# HUDSON RIVER PCBs SITE

## Peer Review of Phase 1 Dredging

### Final Report

September 10, 2010

Figure 2: EPA Phase 1 Report March 2010, Figure I-3-18a

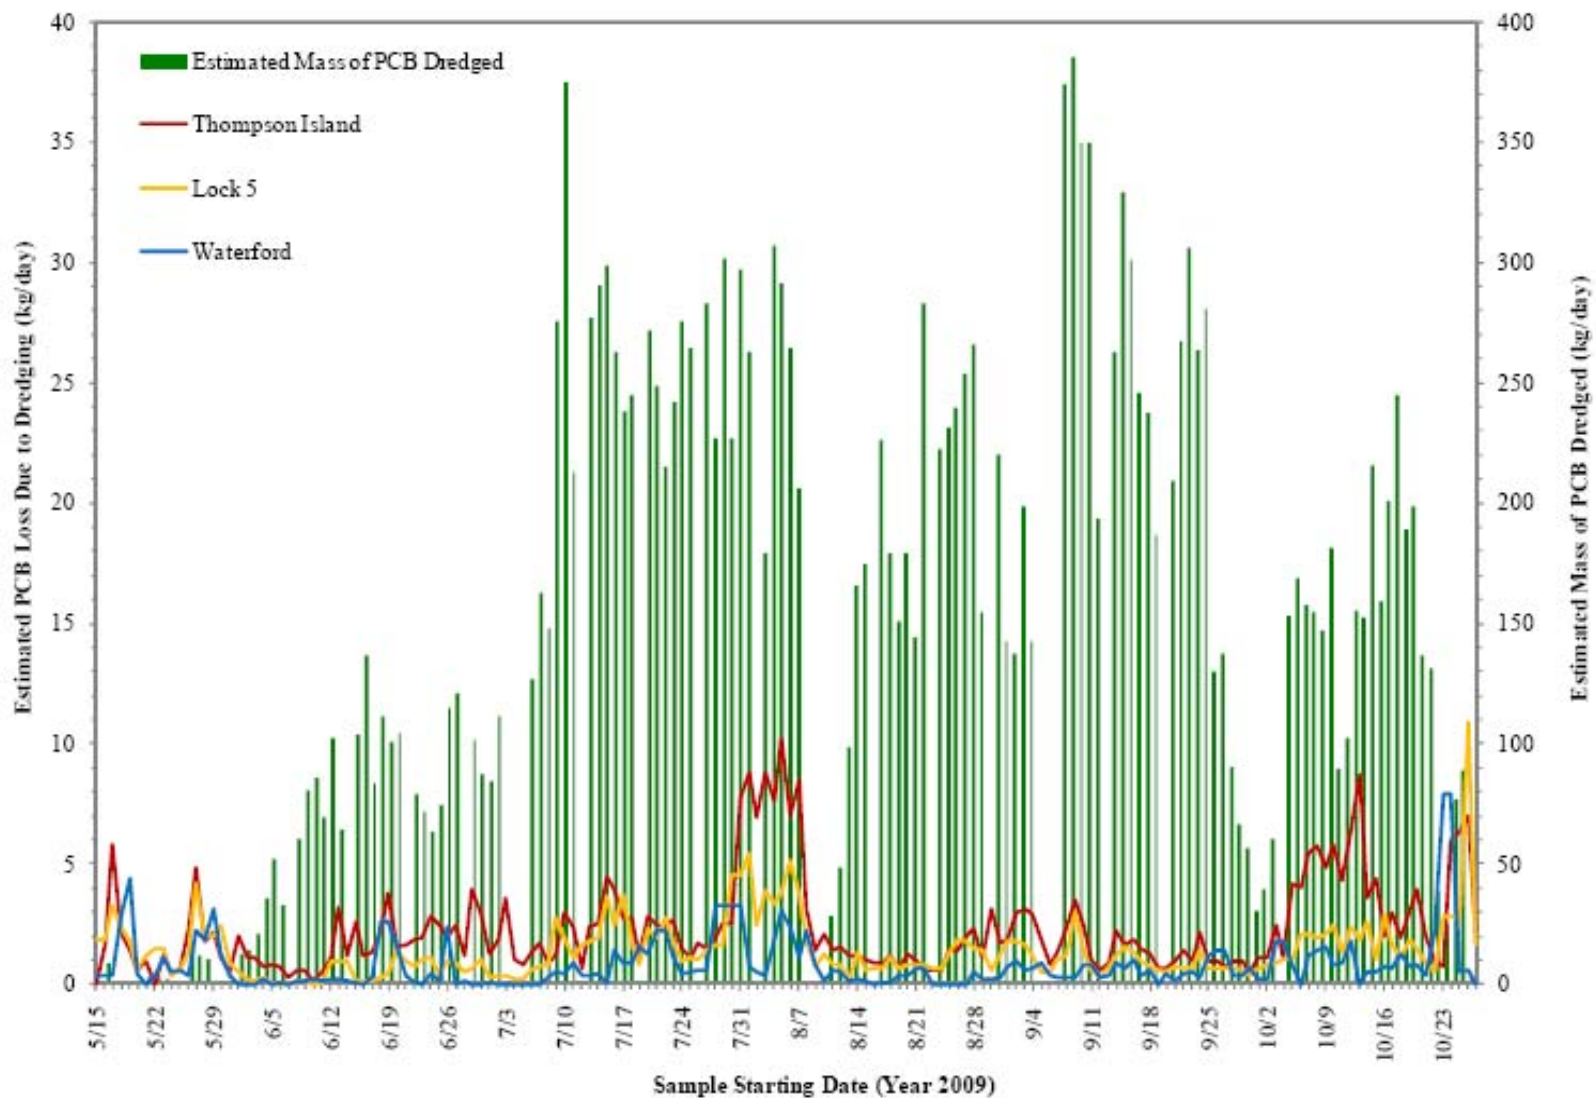
EPA’s Phase 1 Report Figure I-3-18a (Figure 2) presents a compelling representation of PCB mass removed against losses measured at TIP, Lock 5, and Waterford. The Panel confirmed EPA’s mass removal projection with the data in GE’s Appendix Table G-1c (Summary of Daily Bucket Analysis by CU), and the release rates at the TIP with GE’s Figure 5.3-8 (Net Total PCB concentrations at Thompson Island) (Figure 3). While dredge releases are a contributor, there does not appear to be a consistent relationship between mass removed and mass lost solely by the physical act of dredging. Based on EPA’s

analysis, PCB release is not solely controlled by dredging rates or mass removed. GE presented an empirical model that relies on rates of dredged PCB mass removed plus current velocities to predict water column PCB concentrations and resuspension release rates at Waterford. The model reasonably predicts Waterford PCB concentrations, suggesting a strong relationship between PCB mass removed and river flow velocities. This information, combined with EPA's analysis, suggests that river flow was a significant contributor to PCB resuspension and release. What is unclear is the extent to which the various aspects dredging operations contributed to resuspension and release (e.g., open CUs, scow operations, dredge rates, dredge depths, bucket size, bucket overflow, and other dredge-related unit processes, such as single lane advance of dredging downstream).
